UNITED STATES PATENT AND TRADEMARK OFFICE

10/615,407

Office Action Summary	Application No. 10/615,407	Applicant(s) SANTISI, PHILLIP M.	
	Examiner JAMES R. BRITAIN	Art Unit 3677

DETAILED ACTION

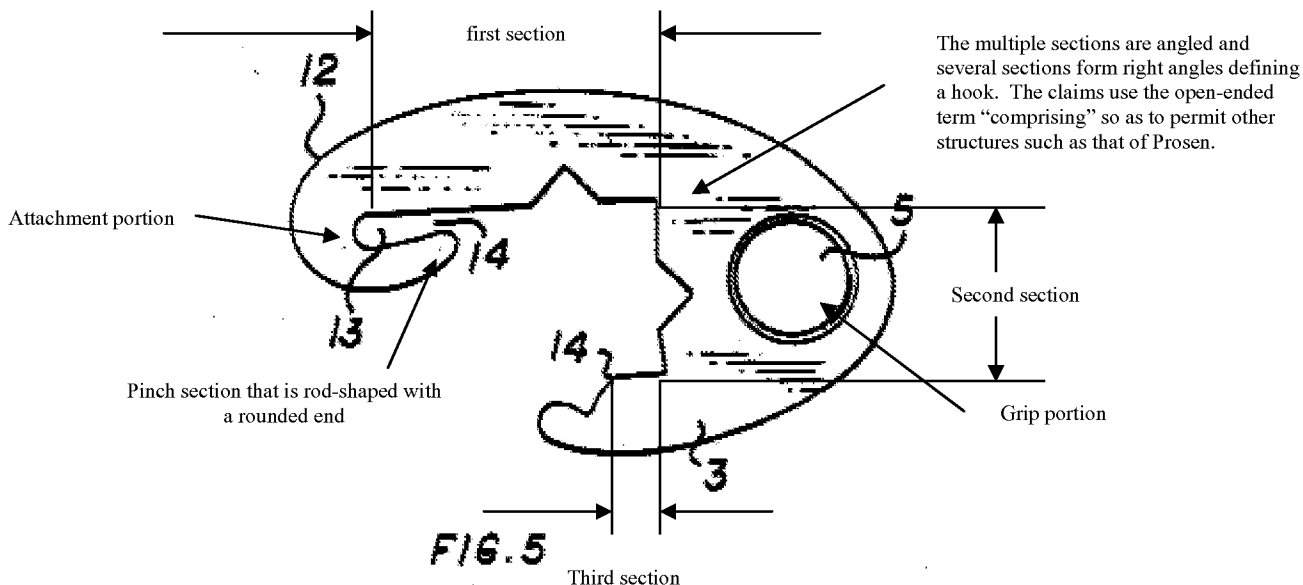
Prosen (figure 5) teaches a clasp 3 comprising a hook portion, a grip portion and an attachment portion, the hook portion comprising a first section, a second section and a third section, wherein the first section is connected to and perpendicular with the second section, the second section connected to and perpendicular with the third section.

Prosen utilizes fabric-jacketed elastic cords, which is inherently a bungee cord, to secure loads such as cargo to vehicle racks wherein the configuration of the hook portions are adaptable to securement to a variety of surfaces such as polygonal, cylindrical and irregular surfaces. As claim 1 utilizes the open-ended language “comprising” and the pinch section identified above is rod-shaped with a rounded end thereby meeting the claim language while permitting other structure such as the flattened plate portions extending from the rod-shaped pinch section with a rounded end. Further, applicant doesn’t use --consisting-- so as to preclude any other structure such as the notches in the middle of the straight first and straight second sections.

As to claims 6 and 7, these relative dimensions are formed by sections of the hook portion of Prosen’s device. In regard to claim 8, figure 6 of Prosen shows the hook portion in a single plane. As to claim 9, figure 5 shows that it is possible to configure planes perpendicular to the plane of the paper and aligned with the first and third sections. In regard to claim 11, the claims utilize the open-ended language “comprising” and the pinch section identified above is rod-shaped with a rounded end so as to meet the claim language while permitting other structure. As to claim 15, the pinch section identified above is between and therefore separates the grip portion from the attachment portion. In regard to claim 16, the pinch section identified above pinches the cord and therefore keeps that portion of the cord from entering the grip portion 5. As to claim 18, cargo is considered equipment for a purpose. In regard to claims 21 and 42, as pointed out above there are multiple straight angled portions connected together to form a hook portion.

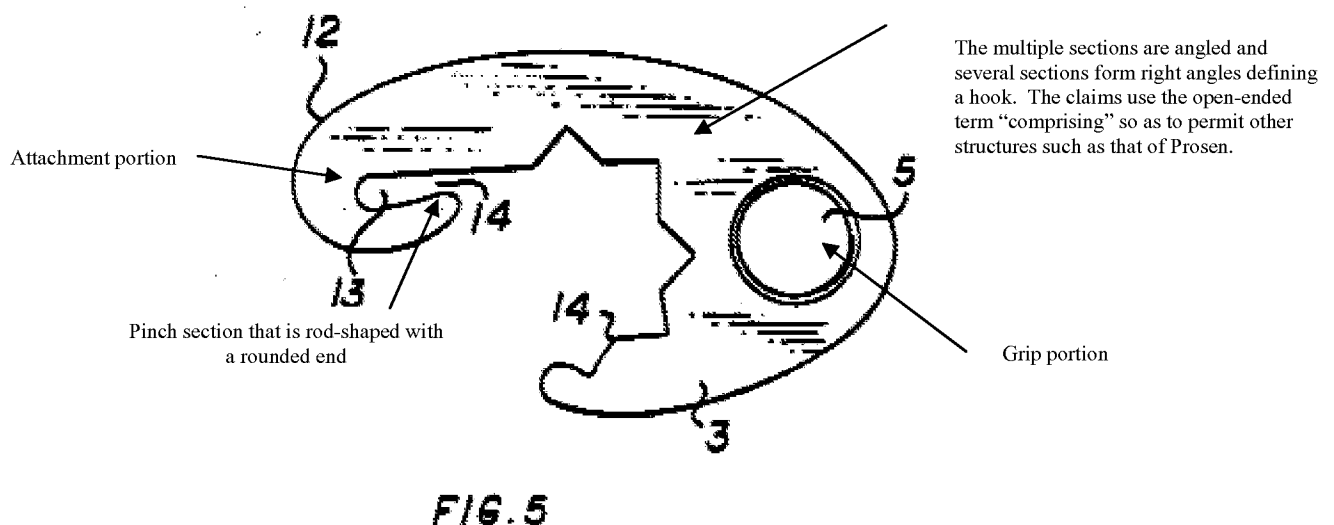
Prosen (figure 5) teaches a clasp 3 comprising a hook portion, a grip portion and an attachment portion, the hook portion comprising a first section, a second section and a third section, wherein the first section is connected to and perpendicular with the second section, the second section connected to and perpendicular with the third section.

Prosen utilizes fabric-jacketed elastic cords, which is inherently a bungee cord, to secure loads such as cargo to vehicle racks wherein the configuration of the hook portions are adaptable to securement to a variety of surfaces such as polygonal, cylindrical and irregular surfaces. The difference with regard to claim 2 is that the hook of figure 5 is an intermediate hook rather than being found at the ends of the cord. However, Chuan (figures 1-3, 5, 7) teaches that it is desirable to secure clasps with grip portions at the ends of the cord without intermediate hooks wherein there are reduced gaps in the attachment portions that would pinch the cord in a similar manner to that of Prosen. As Prosen teaches that it is desirable to configure the hook portion with perpendicular portions for both the end hooks and the intermediate hooks and Chuan teaches that it is desirable to secure clasps with grip portions at the ends of the cord without intermediate hooks wherein there are reduced gaps in the attachment portions that would pinch the cord, it would have been obvious to modify the end hooks of Prosen so as utilize hooks with a pinching portion at the ends as taught by Chuan while maintaining the perpendicular sections taught by Prosen since Prosen wishes to keep the angular hook portion because of its greater use in securing the clasp to various shapes. As to claim 5, the devices of Prosen and Chuan describe the typical bungee cord that is well known. In regard to claim 22, this claim is rejected for the reasons identified for claim 2 with the further observation that the pinch section identified above with respect to Prosen pinches the cord and therefore keeps that portion of the cord from entering the grip portion 5. As to claims 12, 13, 27 and 28, Chuan teaches that the use of steel is conventional for forming the hooks as would be expected because of its strength (col. 1, lines 19-25).

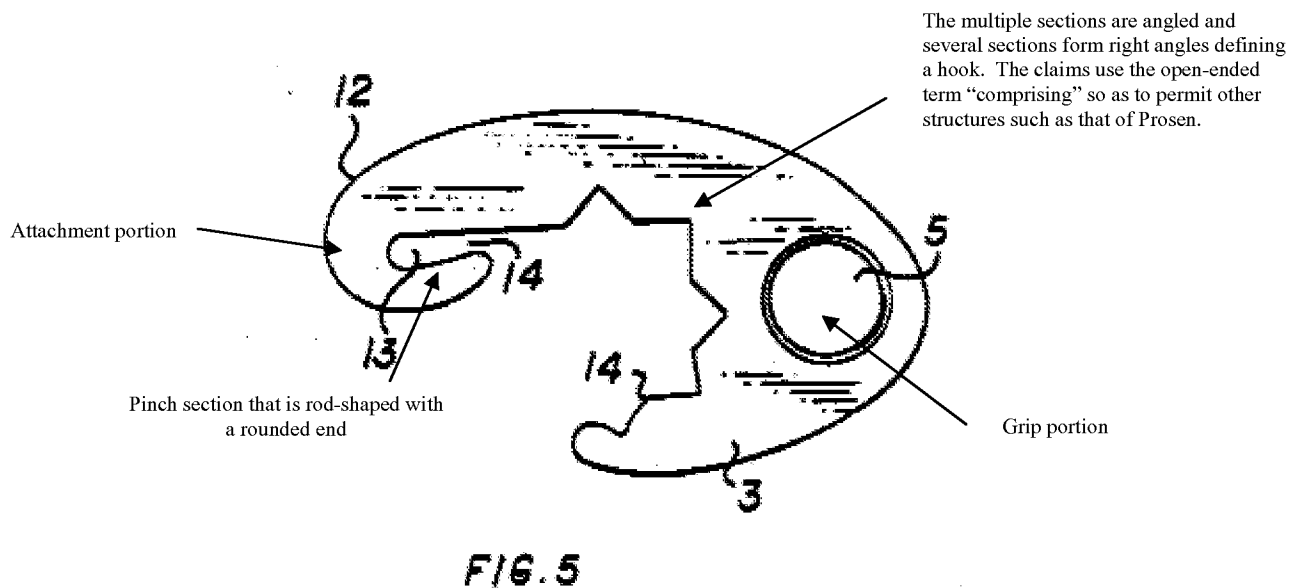
Prosen (figure 5) teaches a clasp 3 comprising a hook portion, a grip portion and an attachment portion, the hook portion comprising a first section, a second section and a third section, wherein the first section is connected to and perpendicular with the second section, the second section connected to and perpendicular with the third section.

Prosen utilizes fabric-jacketed elastic cords, which is inherently a bungee cord, to secure loads such as cargo to vehicle racks wherein the configuration of the hook portions are adaptable to securement to a variety of surfaces such as polygonal, cylindrical and irregular surfaces. The difference is that while metal is stated as being a material (col. 2, lines 15-17), steel and aluminum are not stated as being used. It would have been obvious to utilize either steel or aluminum in view of Simon (figure 2) teaching the use of aluminum or steel as being desirable for clasps because of their ability to resist corrosion (col. 3, lines 8-12).

**FIG. 5**

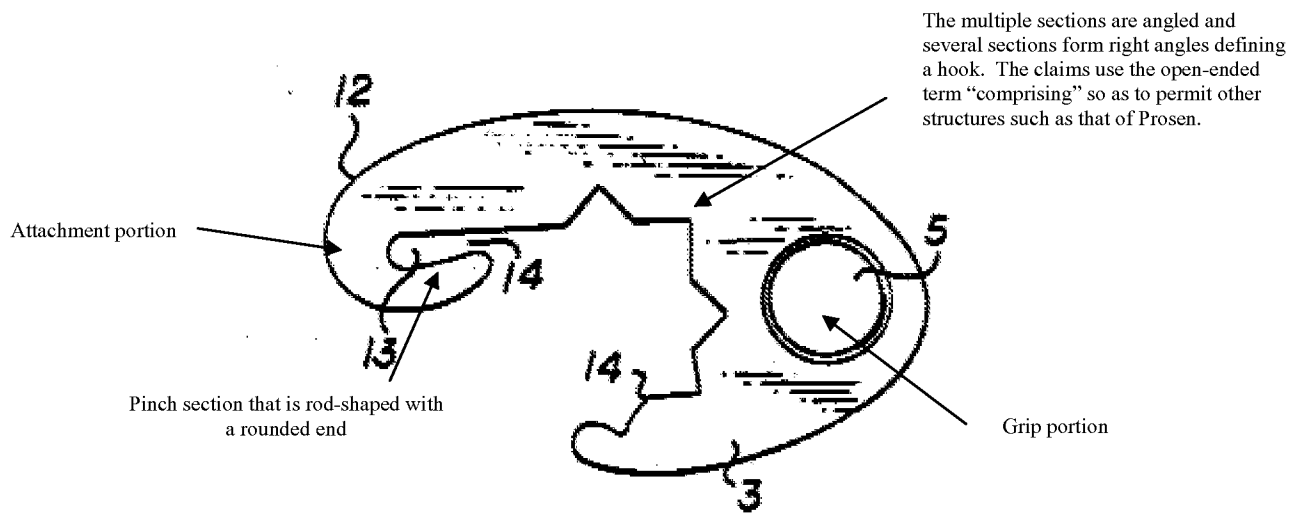
Prosen (figure 5) teaches a clasp 3 comprising a hook portion, a grip portion and an attachment portion, the hook portion comprising a first section, a second section and a third section, wherein the first section is connected to and perpendicular with the second section, the second section connected to and perpendicular with the third section.

Prosen utilizes fabric-jacketed elastic cords, which is inherently a bungee cord, to secure loads such as cargo to vehicle racks wherein the configuration of the hook portions are adaptable to securement to a variety of surfaces such as polygonal, cylindrical and irregular surfaces. The difference is that the first section doesn't separate the grip portion from the second and third sections of the hook portion. Relocation of the grip portion of the device of Prosen so that the first section separates the grip portion from the second and third sections of the hook portion would have been obvious in view of Yonts (figures 2, 3) teaching placing the grip portion 10 so that the first section separates the grip portion from the second and third sections of the hook portion so as to provide a useful way to apply force to attach the hook portion.

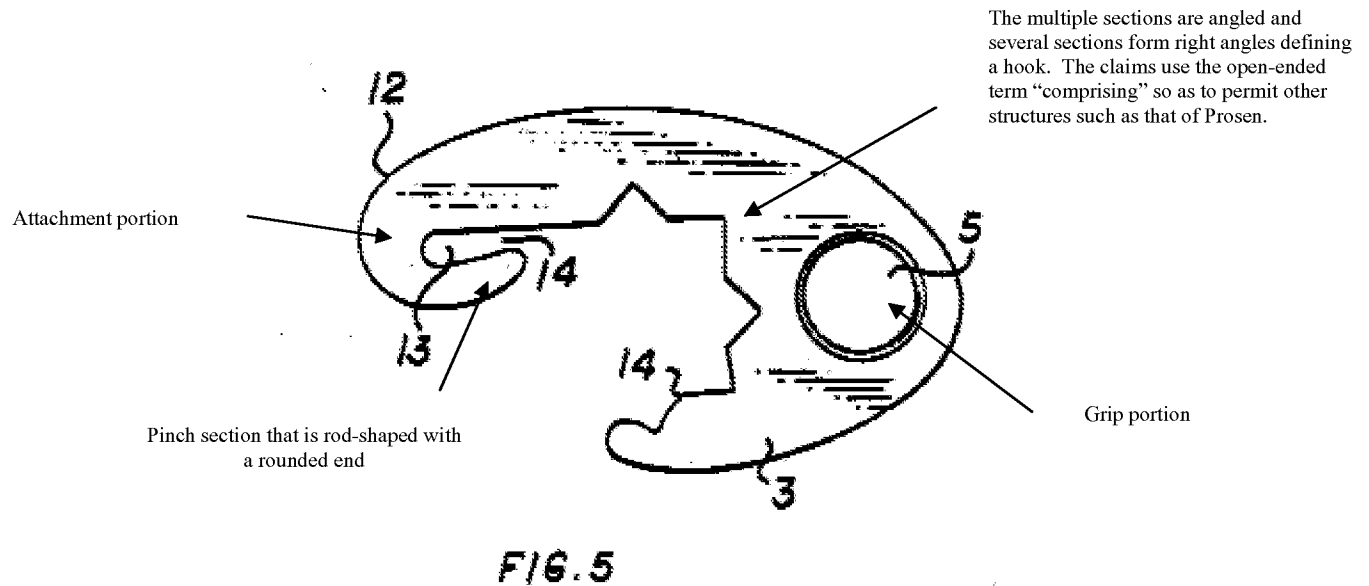
Further modification of the metal clasp of Prosen so that the first section separates the grip portion from the second and third sections of the hook portion would have been obvious in view of Yonts (figures 2, 3) teaching placing the grip portion 10 so that the first section separates the grip portion from the second and third sections of the hook portion so as to provide a useful way to apply force to attach the hook portion.
